RE: 16717 Chirco Drive

I reviewed the drawings and evaluated the neighborhood context. My comments and recommendations on the design are as follows:

PROPOSED PROJECT

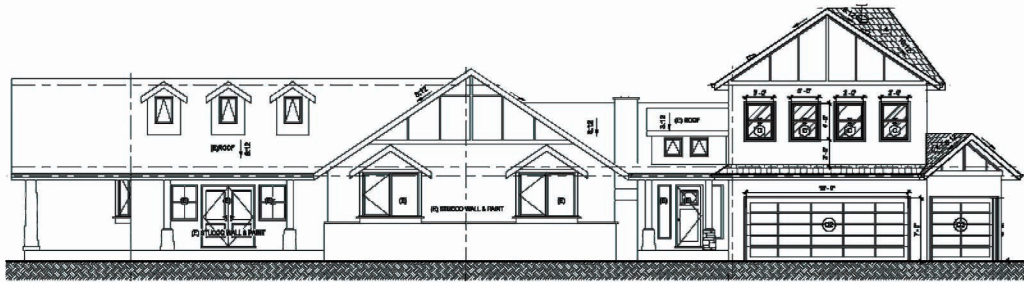
The proposed garage and second floor bedroom addition are not consistent with several Residential Design Guidelines.

1. The addition is very awkward and not consistent with the Residential Design Guideline 3.1 Principles.

Design features, proportions and details shall be consistent with the architectural style selected.

1. Eliminate the awkward angled garage volume on the front facade.
2. Eliminate the awkward angled rear facade gable end.
3. Redesign the addition building form to be more reflective of the existing house and the proposed architectural style.
4. Eliminate the circular driveway and replace a significant amount of the hardscape driveway paving with landscaping.
5. Select garage doors with solid panels and limited transparent glazing.

PROPOSED FRONT SKETCH

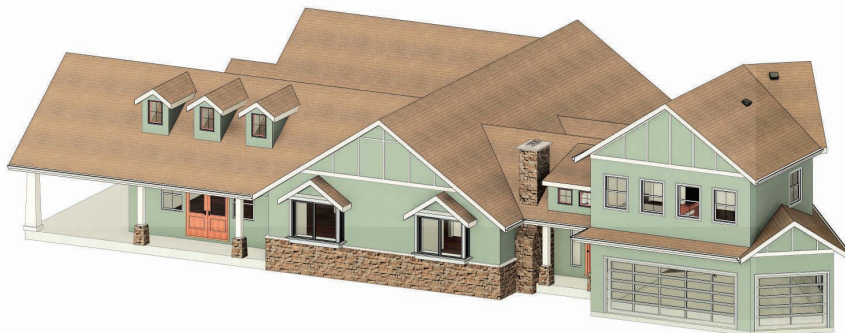
3. The sketch and elevations appear to show metal garage doors with large sections of transparent glazing which, in this neighborhood context, would not be consistent with Residential Design Guideline 3.4.1.

- *Avoid designs that allow the garage to dominate the street facade.*

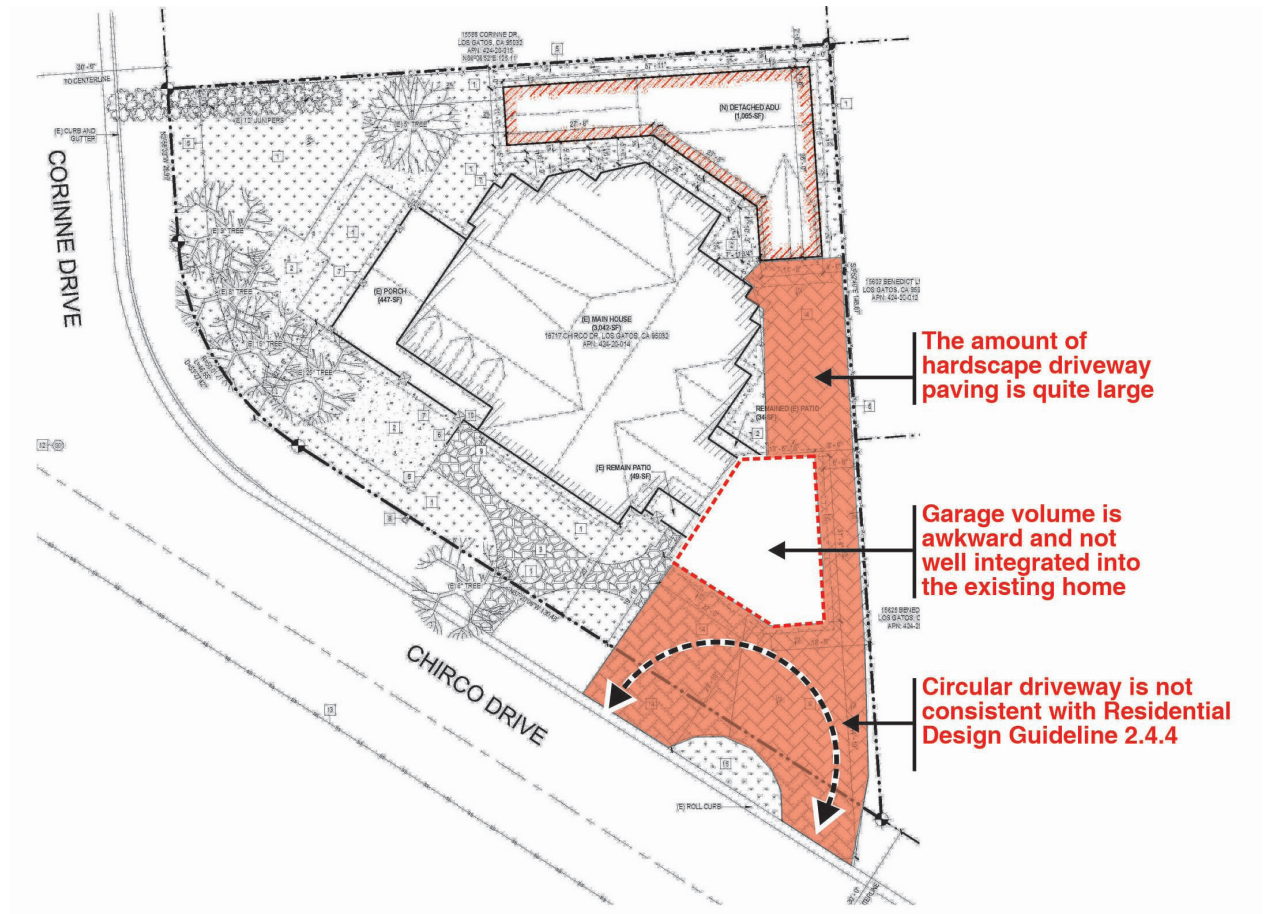
2. The proposed site development plan includes a circular driveway and a very large increase in hardscape driveway paving which would not be consistent with Residential Design Guideline 2.4.4.

- *Circular driveways are discouraged because they increase the amount of paving in front setbacks.*
